Northview

Northview Residents' Association's response to planning application no P101448

Why we are objecting to proposal no P101448

Diagram to show how putting an extra storey will reduce light and create a “well” effect (scale approximate)

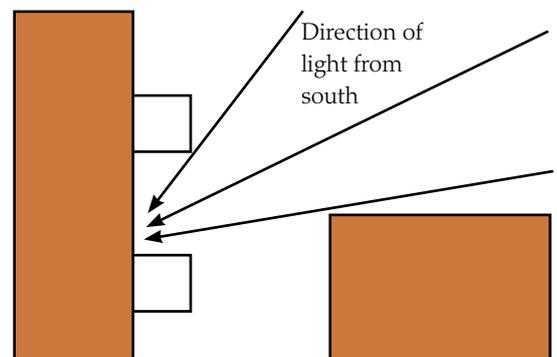
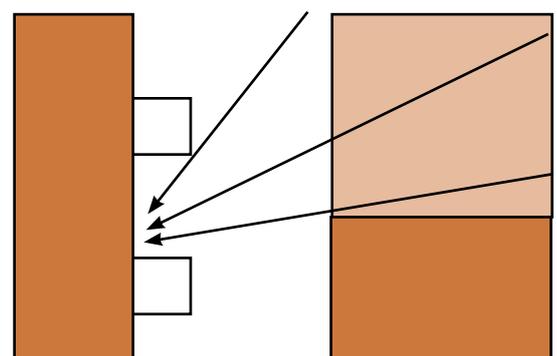
The study says that the four balconies that will fall far short of the vertical sky component test as a result of the extension are set behind overhanging balconies. The consultants add that balconies restrict light.

The pictures shows light at these windows 11 and 14 – the underside of the balcony above cannot be seen, nor does it cast a shadow.

Another curious omission is that the combined effect of the balconies and the extension on daylight is not discussed. While

detailed calculations on other matters are provided, a possible combined effect is omitted from “before and after” calculations. This means that final values may give the impression that the flats will not lose as much light as they will.

The diagram shows how the presence of the overhanging balcony will affect light to window 14. Window 14 is being used to illustrate this as it is on the middle floor; the floor above would probably be affected less and the floor below more so.

Above: existing: 1-12 Northview and its rear balconies are shown on the left; the northernmost part of back block; below: the additional floor will block light to window 14 and create a dark well
